In the matter of Proposed Private Plan Change 31 (PC31) to the
Waimakariri Operative District Plan by Rolleston Industrial
Developments Limited

**Brief of evidence of Shane Bishop on behalf of Waimakariri District Council
(as Submitter) - 3 Waters Infrastructure**

Reference: PPC31 Submission - 3 Waters Infrastructure

Figure 2 Mandeville Sewer - Pipe Criticality Assessment (WDC AcMP 2021)

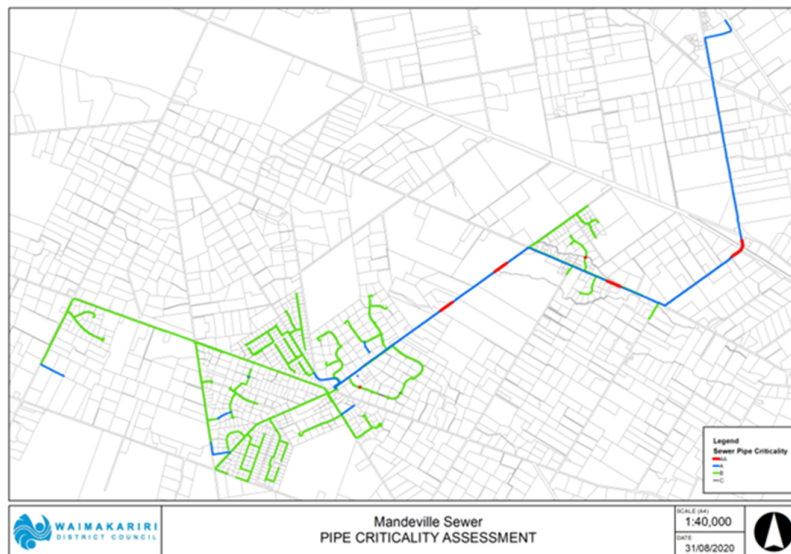
Options for servicing the development area have been presented in the Assessment. These entail either 1) Gravity System plus LPS or 2) Local Pressure Sewer System. Given the high groundwater table and the flat terrain there is merit in considering a pressure sewer system (PSS) to service the catchment. WDC would need to determine whether this would be an acceptable solution for a development in excess of 850 lots.

In assessing the flows from the development for a PSS, a comparison has been made to the Western Bay of Plenty District Council figures to define PF_{WWF} as 1.5 times ADWF. Using the Mandeville scheme statistics as direct comparison (WDC AcMP 2021) and using the 5 year average figures would equate to a PF_{WWF} 2.0 times ADWF (i.e. 965/481 l/day/connection).

The Assessment has acknowledged that a new pressure main would be required to service the catchment noting that the proposed number of lots is more than twice that of the current scheme. Noted also is that the likely alignment of the pipeline would parallel the existing pipeline. While some obstacles have been listed, greater detail would need to be provided on the available corridor for the installing the new pipeline. For example, there may be limited space within the berm to install the new pipeline meaning it may need to be installed either at the edge of or within the carriageway.

The summary of flows from the Mandeville Area Wastewater Scheme in the Assessment has accurately identified that there is currently spare capacity and that peak flows are at least partially balanced within the STEP tanks system. Further calculations would be taken to determine how the two schemes could interact.

Figure 3 Stormwater Model Extents (PDP 2022)

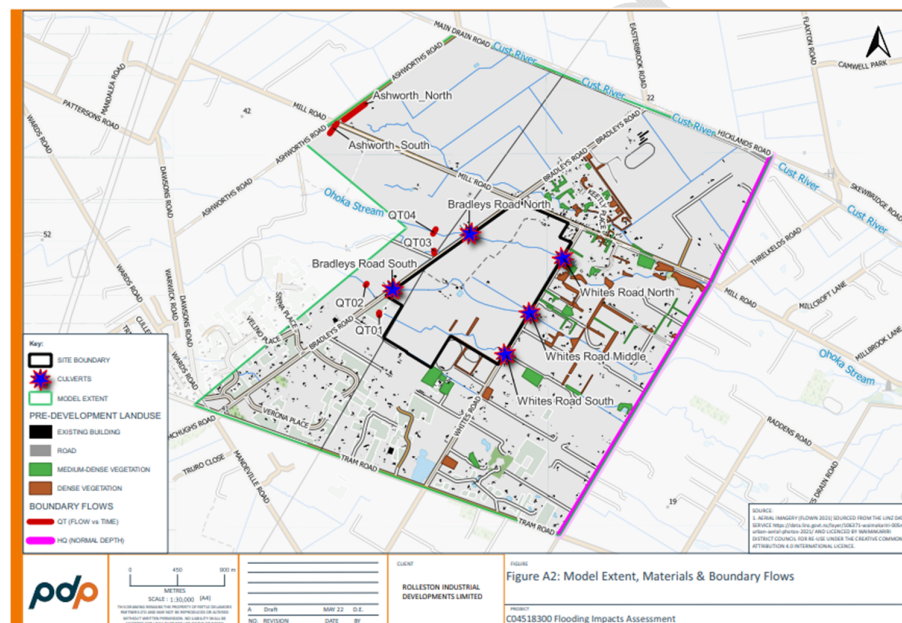
There are no comments within the Assessment regarding the capacity of the culverts or any alterations that might be required.

Figure 4 Indicative Well Spacing (500 m)

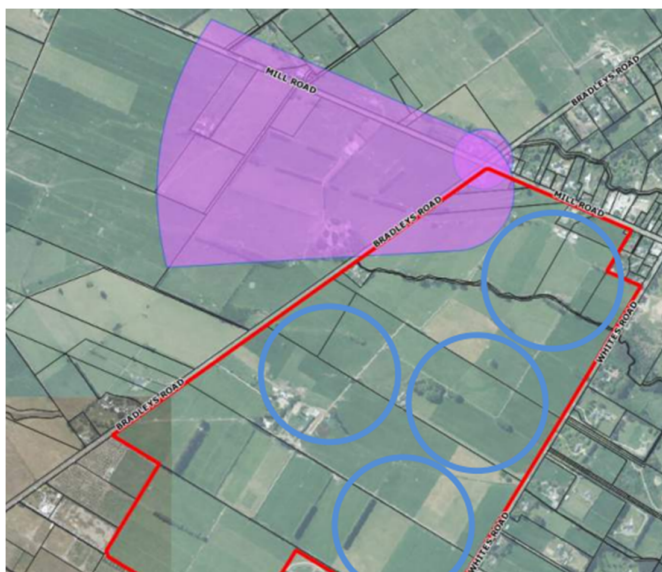
Currently there are shallow wells within the development used for irrigation with a abstraction capacity (both daily and annually) in excess of what would be required for the development. The proposal within the Assessment is that the Consents be transferred to WDC for use as a Community drinking water supply with the consent conditions changed to reflect abstraction from wells at a deeper level. The current wells are up to 19m deep while the well for the current Ohoka water supply scheme is drawing water from 77m deep. Confirmation would need to be obtained from ECan for this approach. For reference, the location and the area of influence for the each of the four wells is provided in Figure 4 (sourced from figure 11 in the Assessment)

The provisions allowed for source water for the subdivision is from three wells and with a fourth well online. This is consistent with the WDC ECoP to have redundancy in supply (N+1 bores for example).

Treatment requirements for the supply source has not been addressed within the Assessment. It could be assumed that given the bores would be abstracting water from the same aquifer (70-80 m) as the existing Ohoka Water Supply scheme that the same water quality parameters would apply. However, this would not be certain until such time as the wells are developed. This risk needs to be raised and addressed within the submission.
